**Comment on the Environmental Impact Assessment Report of
Expansion of Hong Kong International Airport into a Three-Runway System
To the Legislative Council of Hong Kong
by Airport Development Concern Network**

August 16, 14

中港空域、空牆及航道問題 對第3條跑道運作及噪音影響

Arrivals and Departures Flight Tracks Exhibit 5.3

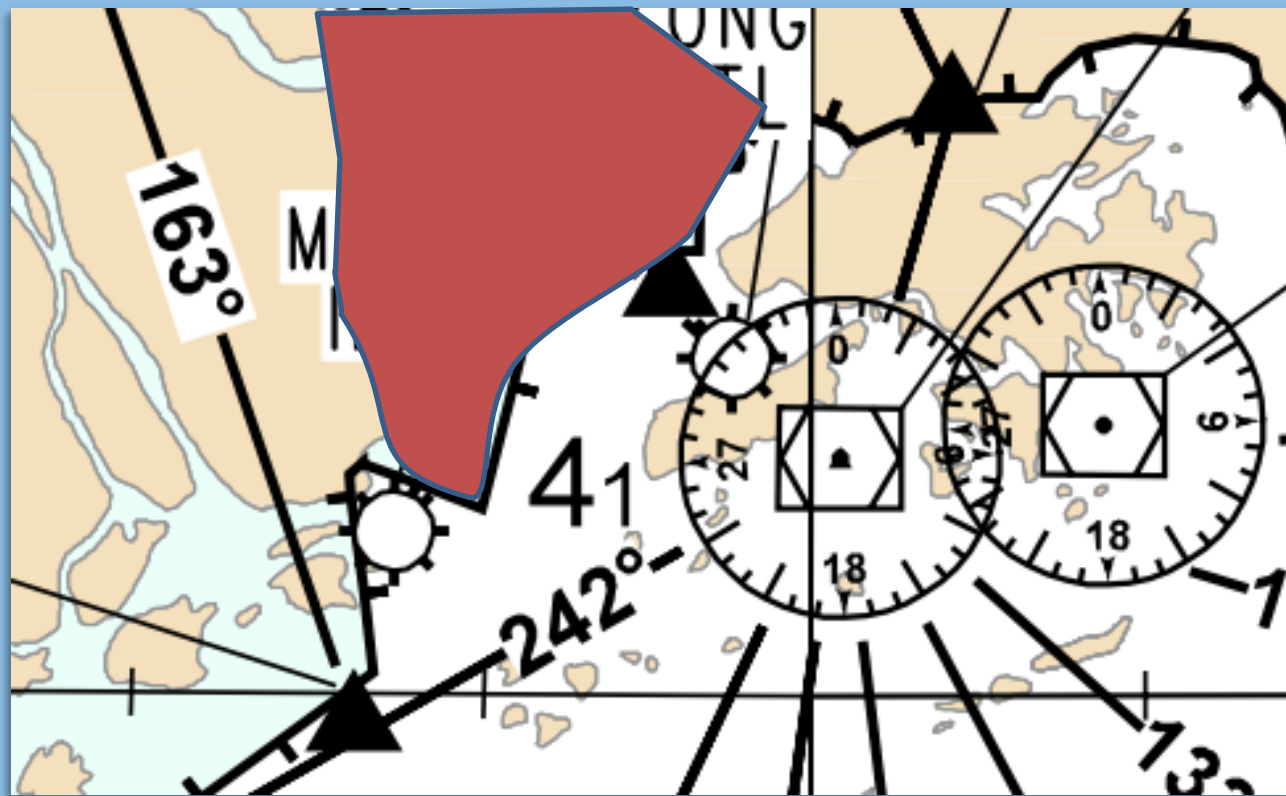
故此，當初設計新機場時有多條北向航道

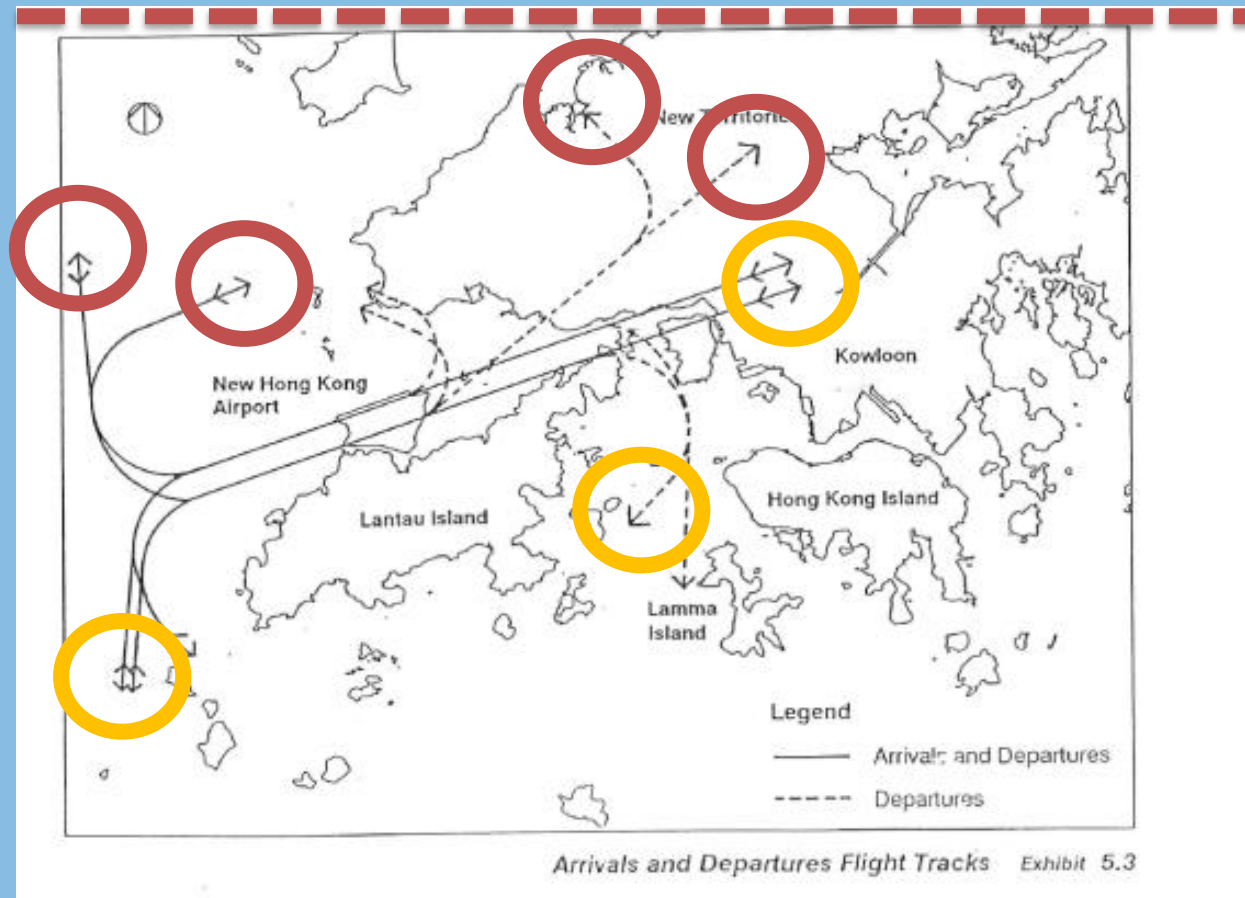
加上深圳機場航班漸多，促使空牆設立

- 需要飛至15700英呎才能進入中國領空
 - 已計劃直線航道(橙線)未能使用
 - 飛機於香港盤旋額外9-20分鐘方能爬升至15700英呎
- 由中國進入香港飛機，需於15000-16000英呎離開中國空域
 - 額外9-20分鐘下降時間

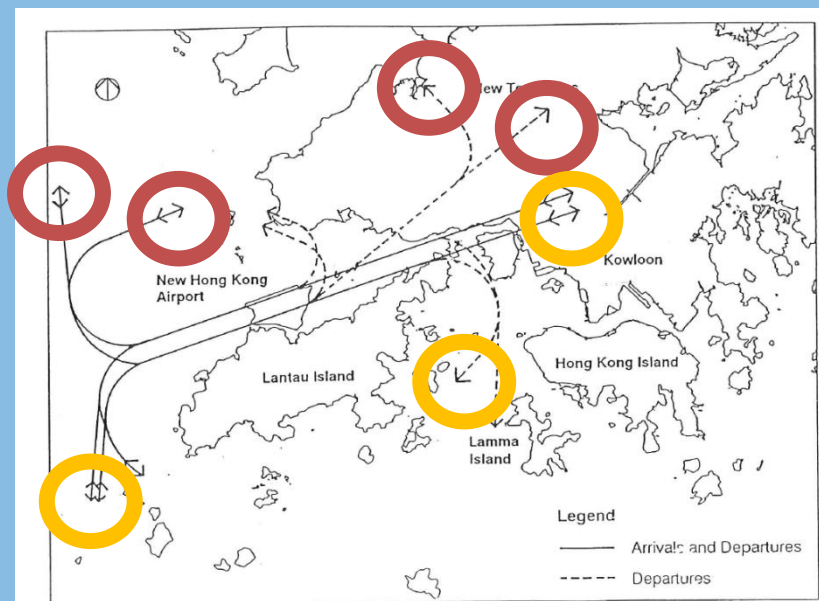
令當初設計的北向航道未能使用

紅色

- 所有方向不能使用

橙色

- 其中一方向未能使用

Arrivals and Departures Flight Tracks Exhibit 5.3

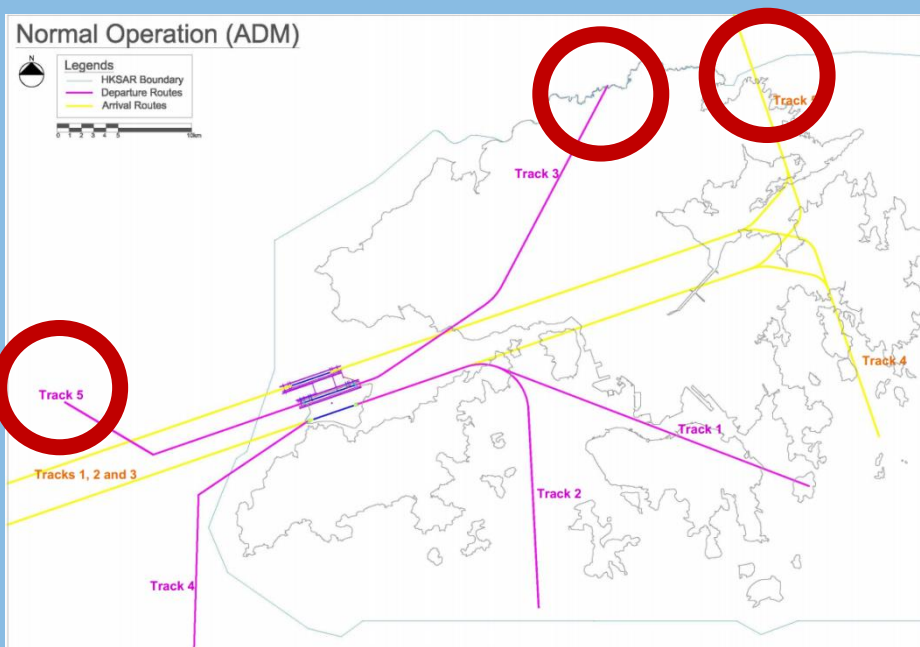
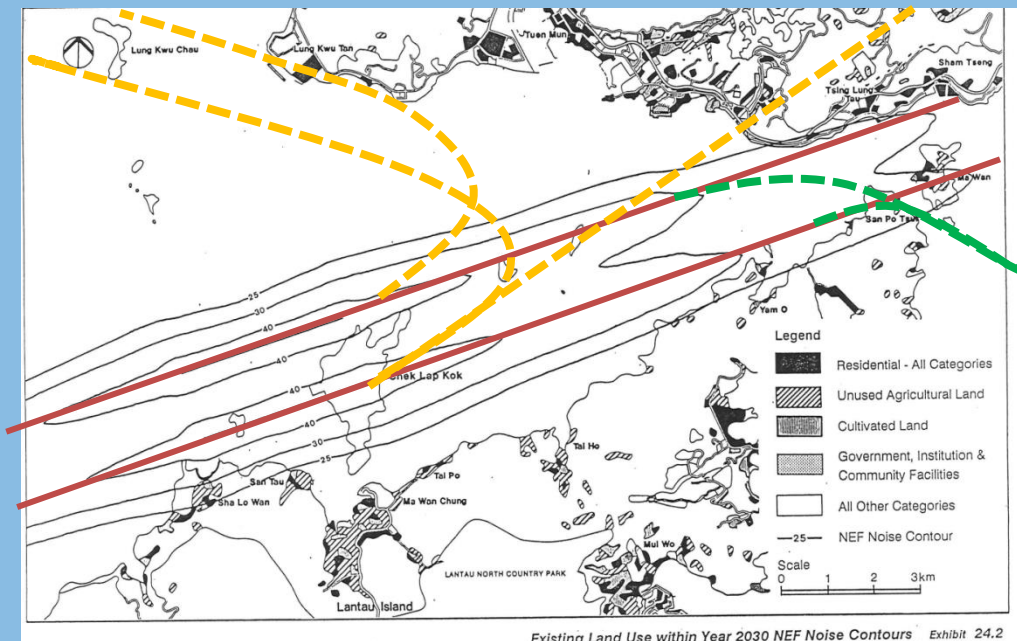
再比較第3條跑道環評的建議航道

現時北向航道無法使用，何以2030年就自然可以使用？

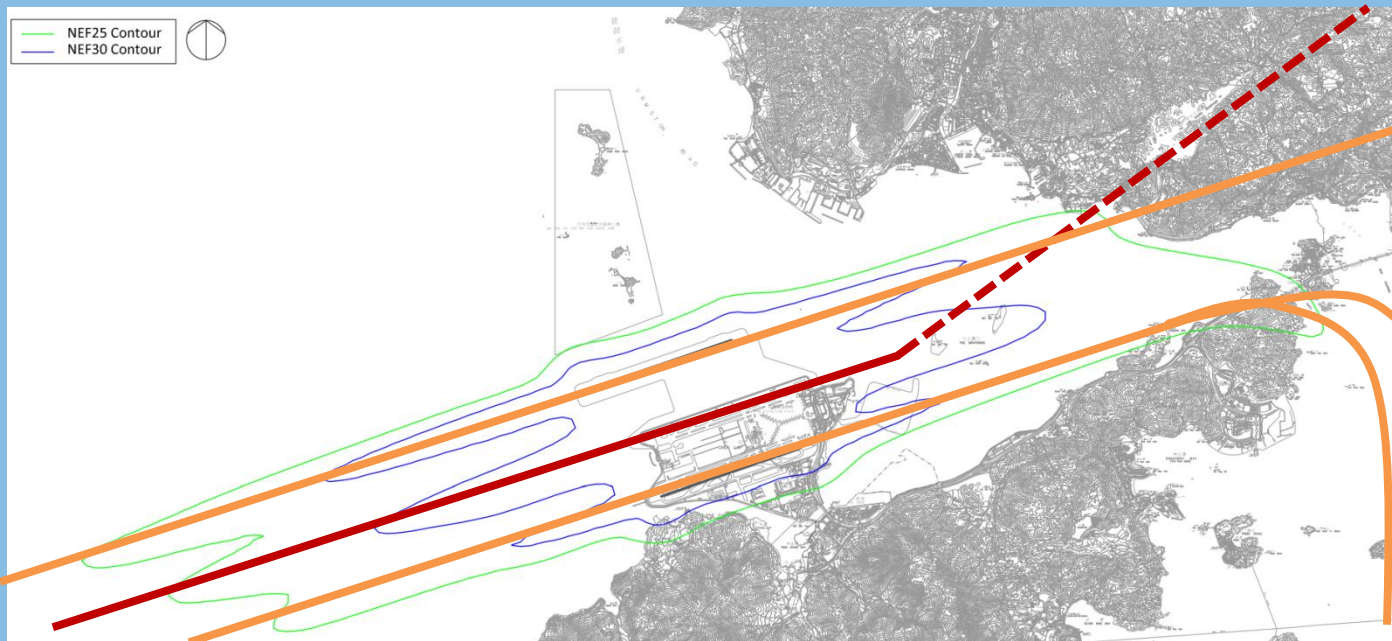
航道假設對噪音評估準確性攸關

- 1992噪音等量線圖
 - 預計2030年噪音影響
- 當中橙色為未有使用航道
 - 飛機集中使用紅線及綠線航道升降
- 集中部份航道升降引致噪音影響變化
 - 未有實質計算

2030年第3條跑道又會如何？

假如紅色航道
虛線部份因空牆
問題未能使用

- 飛機需要市區
起飛時引致的
噪音影響變化
- 機管局未有於
環評報告中交代
